Application for Certificate of Appropriateness

Address of Subject Property: 971 Oakdale Road

PROJECT:
KINSELL RESIDENCE

From: [Davis Bishop](#)
To: [Paige V. Jennings](#)
Cc: [Michael DeCarlo](#); [Brian Field](#)
Subject: Re: Questions Regarding Application for 971 Oakdale Road
Date: Wednesday, May 14, 2025 4:52:53 PM
Attachments: [image001.png](#)
[250514 - 971 Oakdale Rd plans for COA Review.pdf](#)

DRAWING TITLE:
SCREEN PLANTING PLAN
HPC CERTIFICATE OF
APPROPRIATENESS

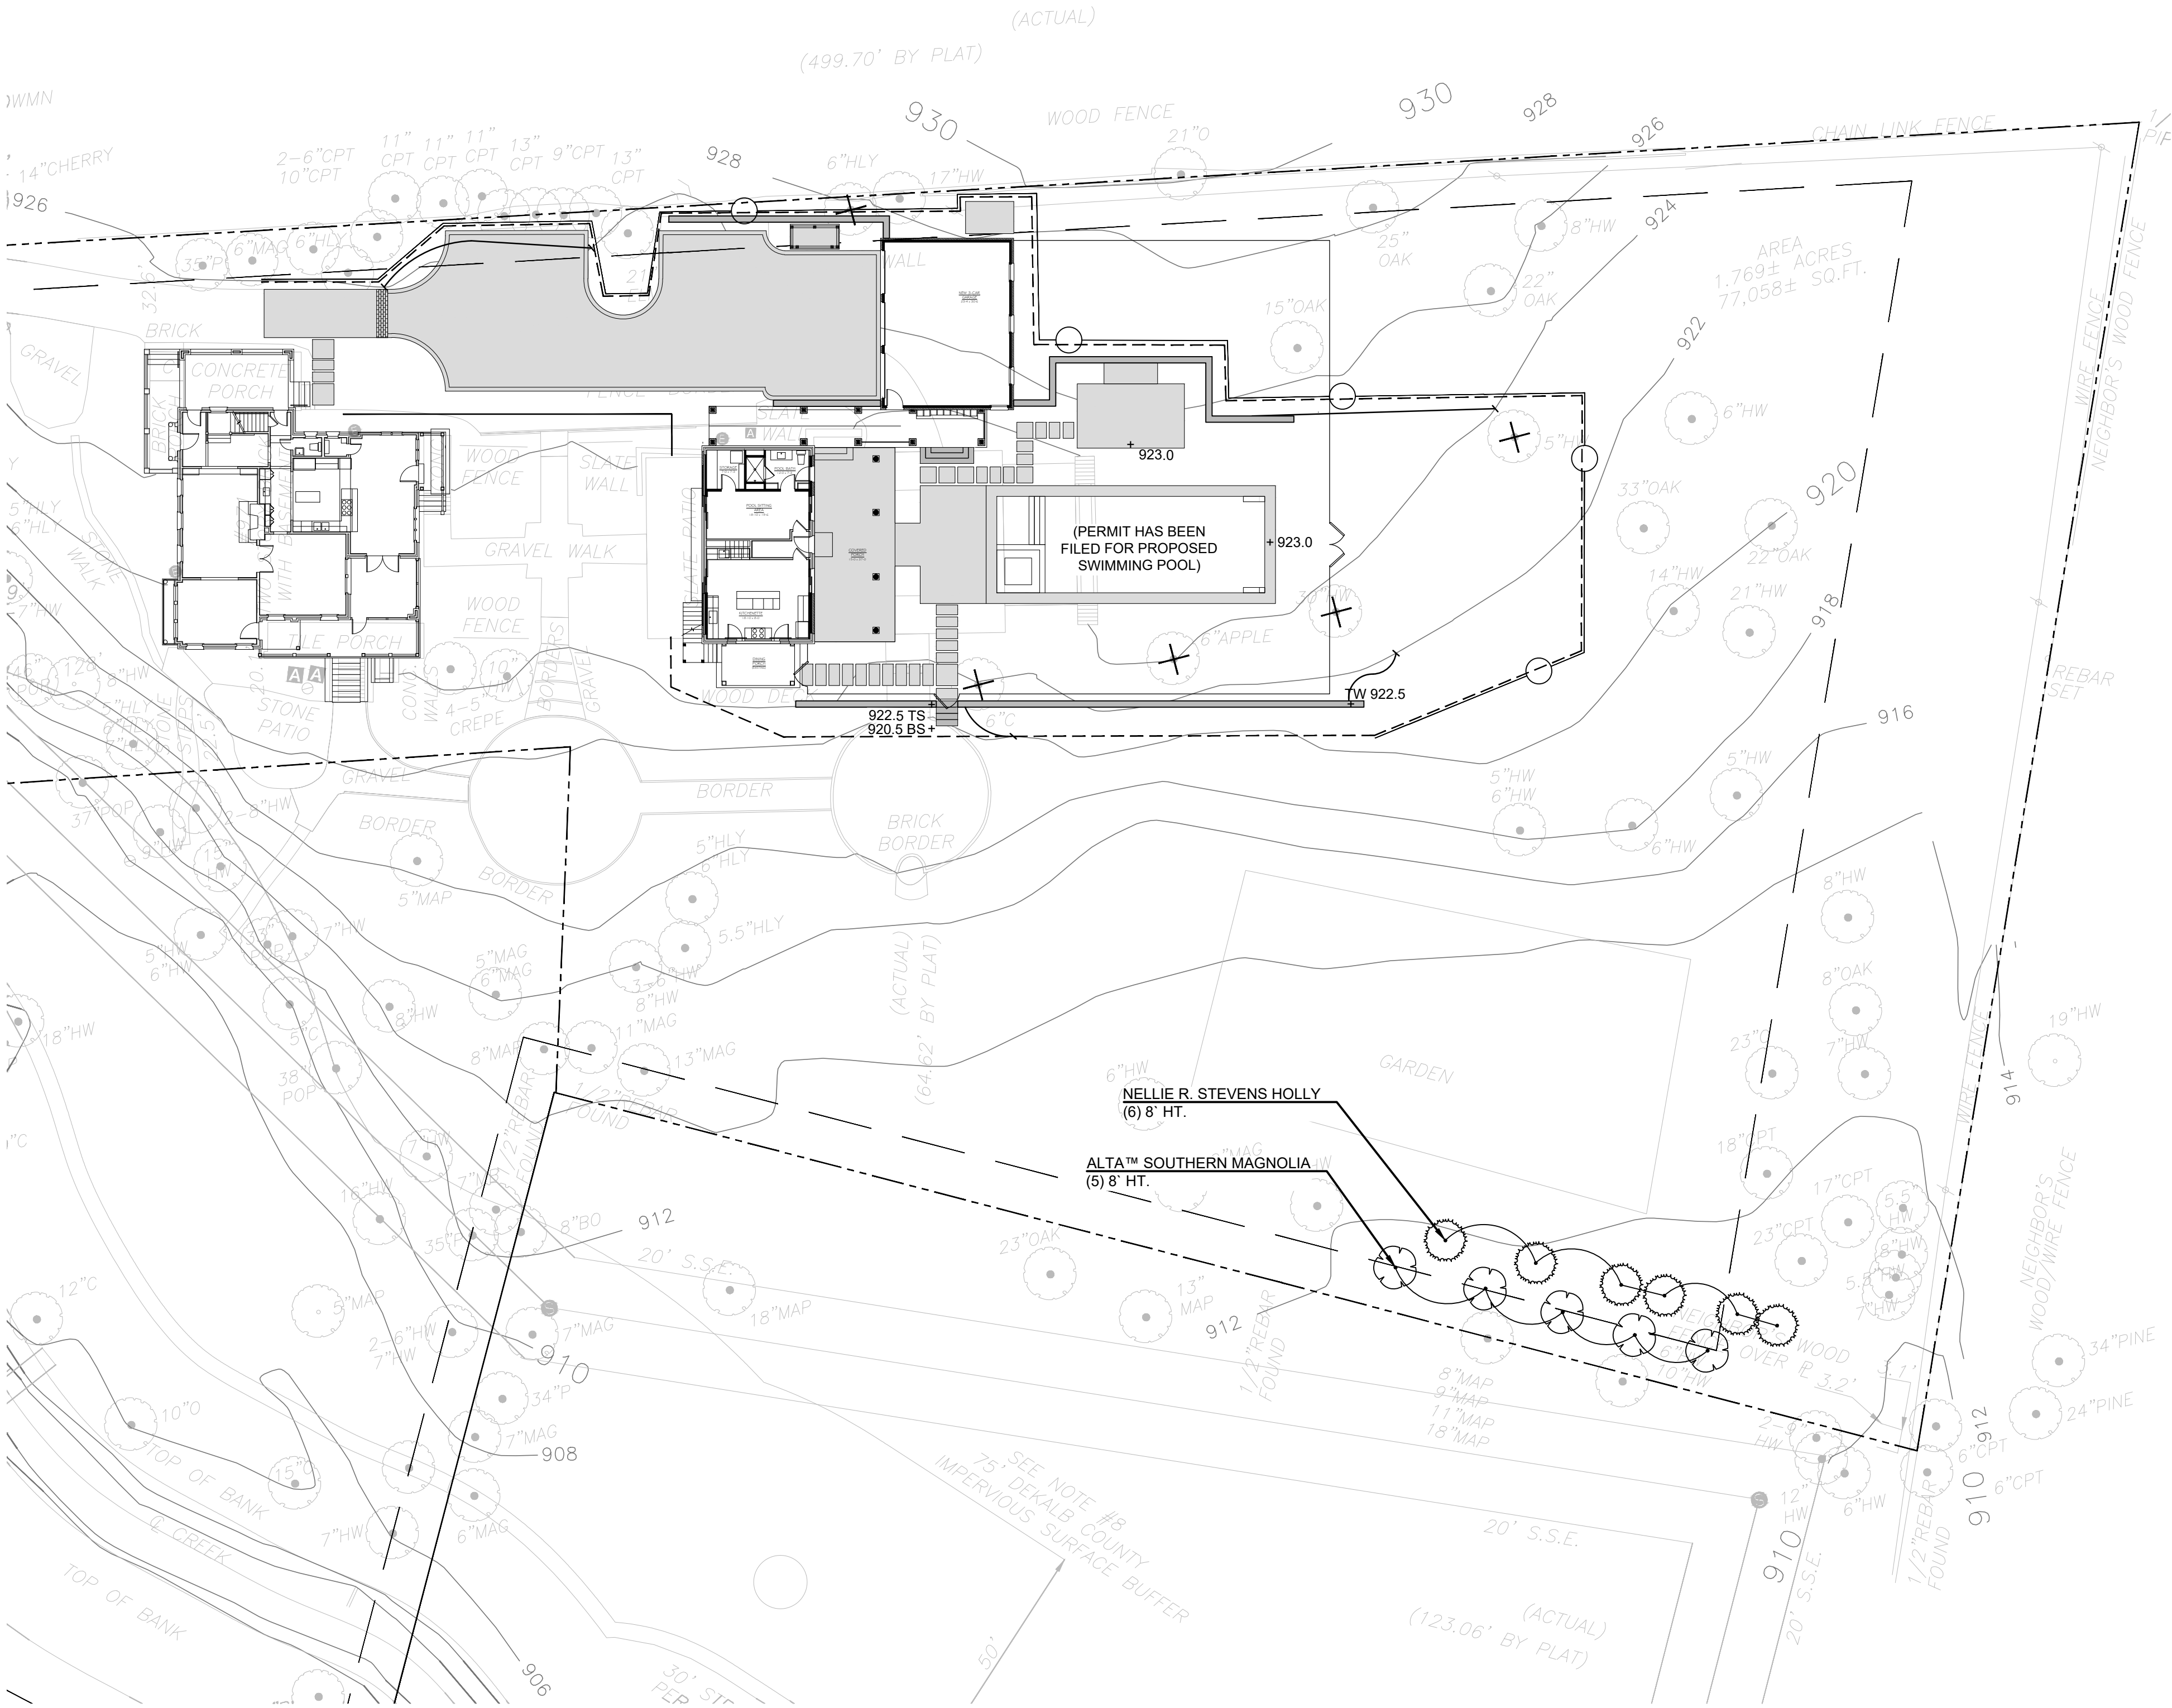
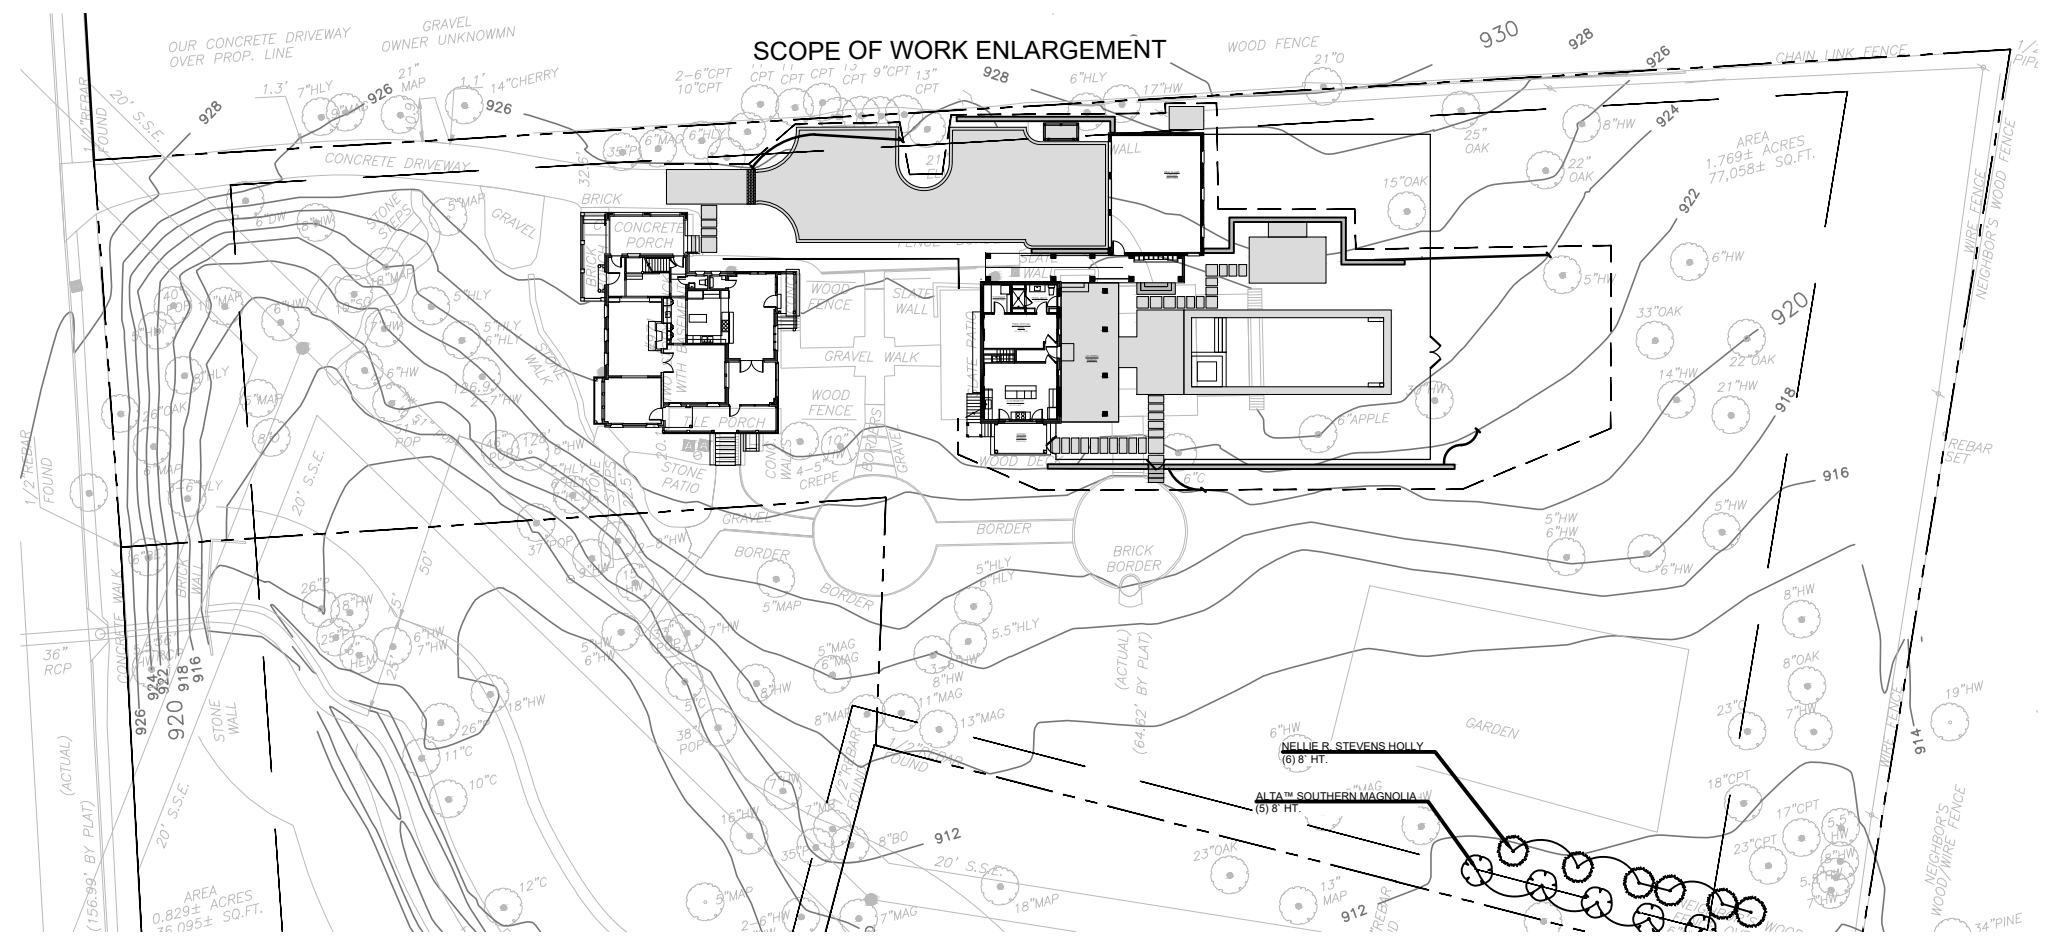
The application documents are unclear as to specifically what will be planted along the border between 971 Oakdale & 1366 The By Way.

Mr Kinsell confirmed that the plans will be modified to show those plantings will be

- 1) EVERGREEN and
- 2) be with typical heights of 15-20 FEET and
- 3) be of an interspersed variety of a few species and
- 4) be planted in a natural, off-center staggered fashion.
